# CALIFORNIA DEPARTMENT OF TRANSPORTATION FINDING OF NO SIGNIFICANT IMPACT (FONSI)

## VEN-1 Permanent Slope Restoration Project

**NEPA/CEQA RE-VALIDATION FORM**

<b>DIST-CO-RTE:</b> 07-VEN-01
<b>PM/PM:</b> 4.0/4.2
<b>EA or Fed-Aid Project No.:</b> 31820/0715000286
<b>Other Project No. (specify):</b> SCH# 2017101045
<b>Project Title:</b> VEN-1 Permanent Slope Restoration Project
<b>Environmental Approval Type:</b> IS with ND/EA with FONSI
<b>Date Approved:</b> June 12, 2019
<b>Reason for Consultation (23 CFR 771.129), check one:</b> <input type="checkbox"/> Project proceeding to next major federal approval <input checked="" type="checkbox"/> Change in scope, setting, effects, mitigation measures, requirements <input type="checkbox"/> 3-year timeline (EIS only) <input type="checkbox"/> N/A (Re-Validation for CEQA only)
<b>Description of Changed Conditions:</b> The preferred alternative has been changed from what was identified in the final environmental document and a temporary rather than permanent net mesh on the mountainside has been added to the project scope. See second page for details on the changed conditions.

### Attachment 1: Temporary Cable Net Mesh Area

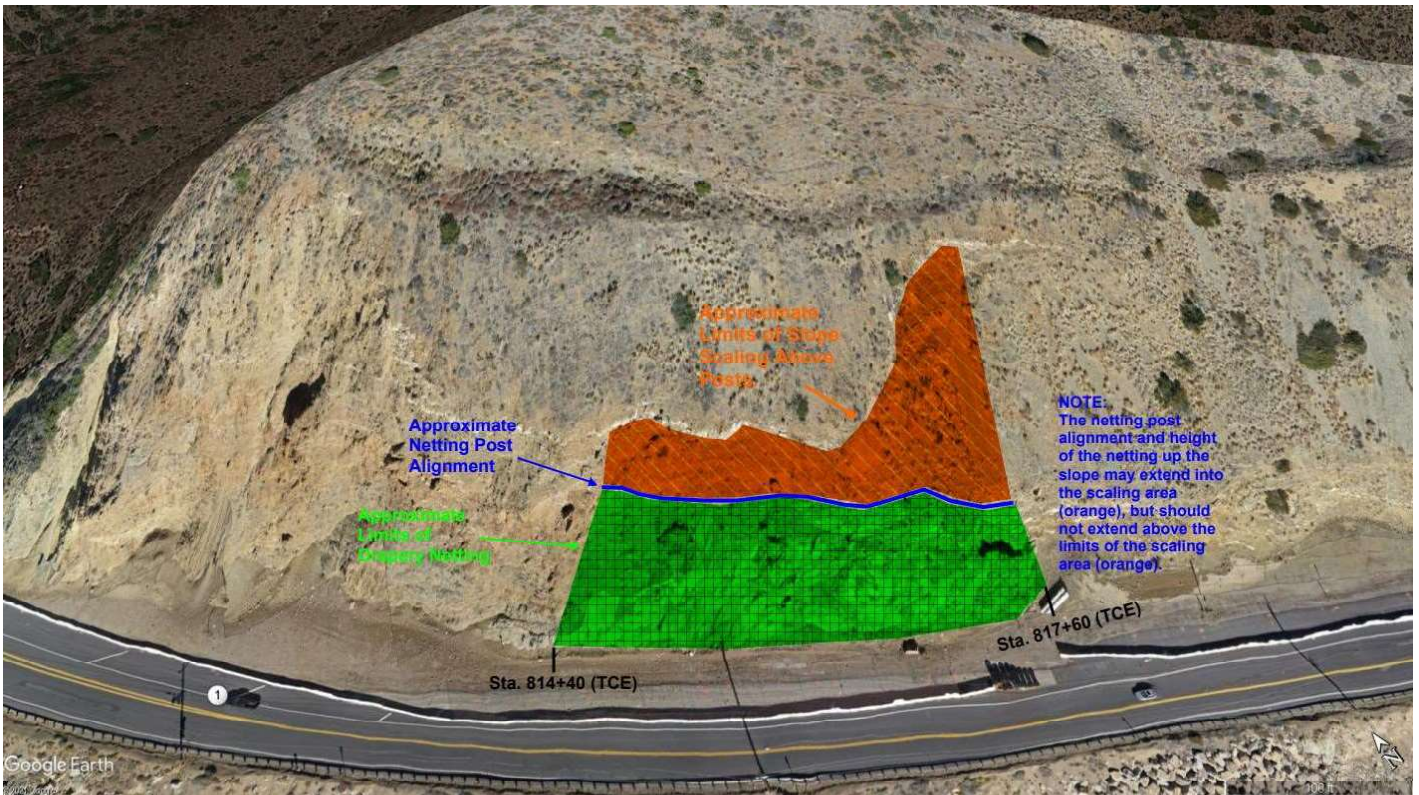
Due to the limited roadway width and needed space for construction equipment, a temporary cable net mesh will be installed spanning from stations 814+40 to 817+60 on mountainside. The net will be installed with anchors, be displayed for about 20 months and then removed. This action is a TCE and will require a Right of Entry permit from CA State Parks and Recs. An image is attached showing the area of the hillside where the netting will be installed.

Previously, a larger net mesh area was proposed in the Final IS/EA and it was stated that Caltrans decided the cable net mesh should remain in place to ensure public safety from falling rock. However, due to right of way conflict, the netting will be temporary during construction and removed after construction is finished. The k-rail in that area will be restored to its pre-construction condition to block vehicular access to the northbound shoulder, making sure vehicles stay away from falling rock. Moving the k-rail back to this position will ensure the safety of the traveling public.
